C 28

PREAMPLIFIER

SERVICE INFORMATION

SERVICE BULLETIN

HIGH & LOW LEVEL PRINTED CIRCUIT BOARD 044-063

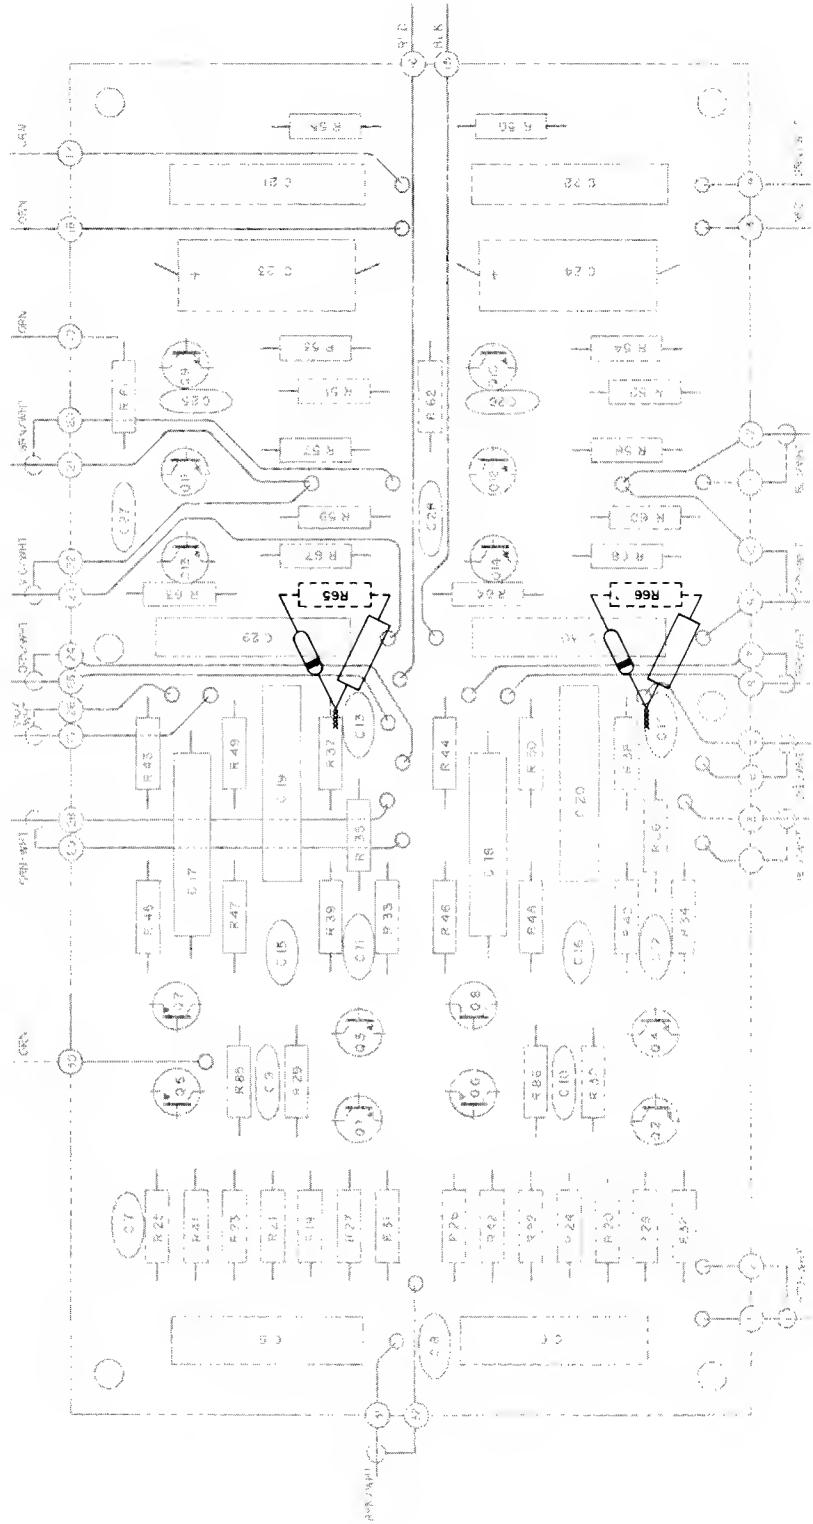
ELIMINATION OF TURN-ON AND TURN-OFF NOISE

PURPOSE OF MODIFICATION: To eliminate the "shhhh" type of noise when initially turned-on, or a second or two after being turned off.

WHAT UNITS ARE AFFECTED: Serial No. 10X01 to 17X01 only.

Step 1: Remove top cover.

Step 2: Remove R65 and R66 (4.7k resistors).

Step 3: Install the new diode and resistor as shown.

BACKSIDE OF LOW LEVEL INPUT PLATE

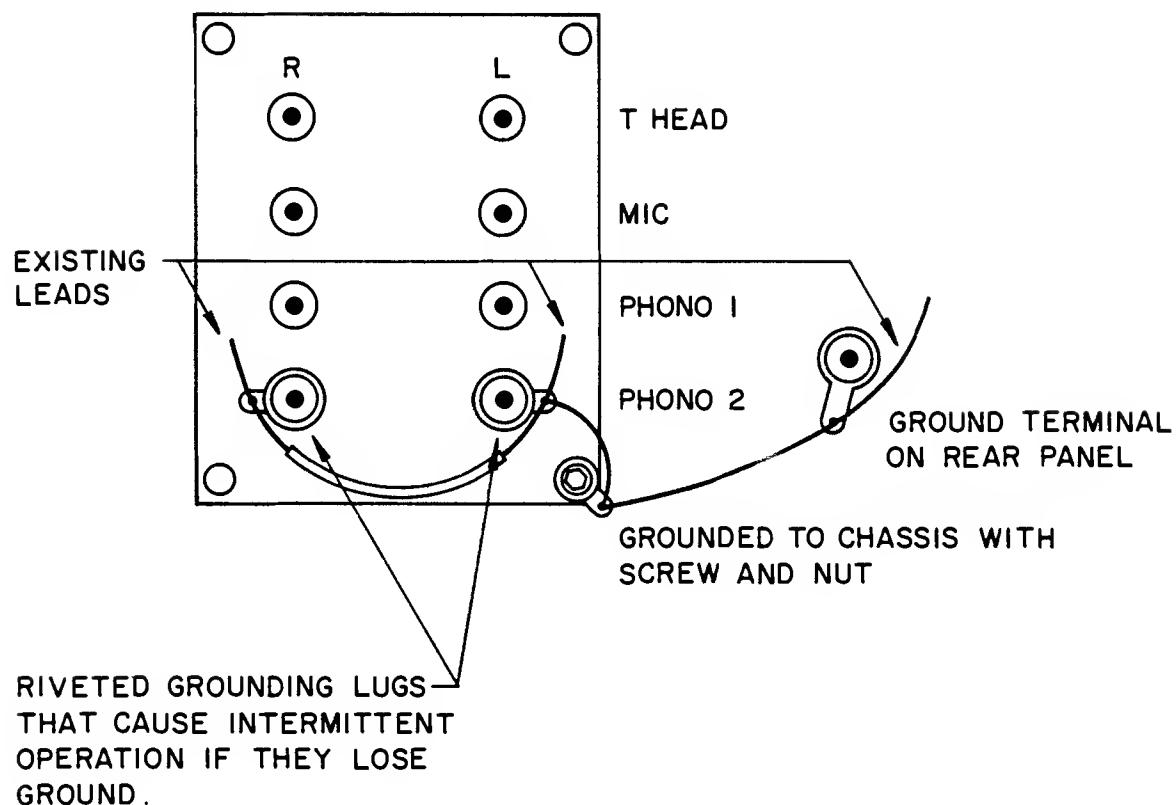
ASSURE GROUND CONNECTION TO LOW LEVEL INPUTS

PURPOSE OF MODIFICATION: To assure that the high and low level amp. PC board 044-309 will always have a positive ground return.

WHAT UNITS ARE AFFECTED: All units with Serial No's. below AS 1660

WHEN MODIFICATION SHOULD BE MADE: When intermittent or complete loss of a channel is experienced in any of the low-input-level modes- or when units are being serviced for any other reason.

1. Remove top and bottom covers.
2. Unscrew screw and nut and place solder lug between plate and rear panel. Tighten screw.
3. Solder bare wire between ground terminal lug on rear panel to newly mounted lug, then another piece of bare wire to rivited solder lug at Phono 2 left.
4. Then solder sleeved bare wire between phono 2 left solder lug and phono 2 Right solder lug.
5. Replace top and bottom covers.

DIAG. 1

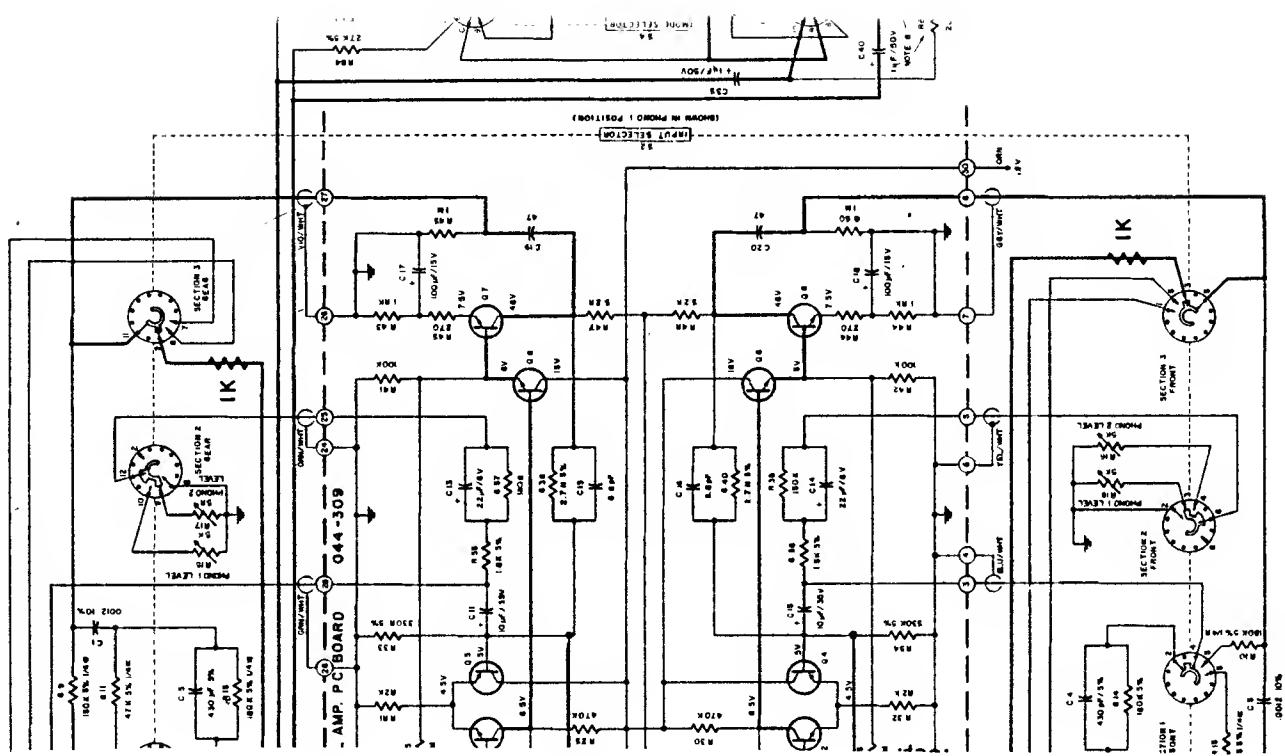
ELIMINATION OF RADIO FREQUENCY INTERFERENCE

Purpose of Modification: To eliminate radio interference caused by Citizens Band Transceivers and other transmitters.

1. Remove top and bottom covers.
2. Remove the screws holding the level set panel in place.
3. Referring to diagram 1 and with the C 28 upside down, locate the four coaxial cables that connect to push button switches, S1-B and S1-D. Insert the 1KΩ resistors in series with each coaxial cable right at the switch terminal.

4. Referring to diagram 1 and with the C 28 upside down, replace each of the two wires (Blue and Blue/white) that connect the front panel "Tape-Output" jack with push button switch S1-B, with 1KΩ resistor. Provide sleeving on both resistor leads.
